Access Compliance Report Public Rights-of-Way (Curb Ramps)

Main Street: E_CHAPMAN_AVE		Cross Street: EARLHAM_ST		Location:	NW
ADA ID: RPAT210929151105	Ramp Type: Type 4 - Parallel	Initial Pass/Fail: Pass	Overall Compliance: No	Severity Score:	10
Codes/Mitigation Info/Possible Solution			Field Measurements/Component Compliance

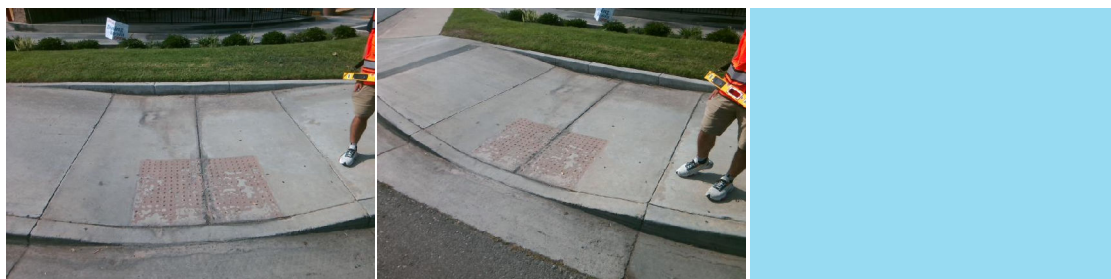
N/A	Ramp Inside Crosswalk 1	N/A	N/A	Ramp Inside Crosswalk 2	N/A
	Crossing 1 Slope (%)	4.1		Crossing 2 Slope (%)	4.6
	Crossing 1 Cross Slope (%)	1		Crossing 2 Cross Slope (%)	3.5
Yes	Gutter Ponding	No	Yes	Curb Slope	4.3
Yes	Gutter Lip Height (in)	0		Road Run Slope (%)	1.2
No	Gutter Run Slope (%)	5.6		Road Cross Slope (%)	4.5
Yes	Gutter Cross Slope (%)	0.1	Yes	Perpendicular Joint Present	Yes
Yes	Overall Surface Condition	Acceptable			
	Cross Gutter Present?	No		Spandrel Present?	No
	Replace Cross Gutter?	N/A		Replace Spandrel?	N/A

Remove & Replace Detectable Warning System.
Remove & Replace Gutter.

R305.1.4, R304.5.4, STD 1115
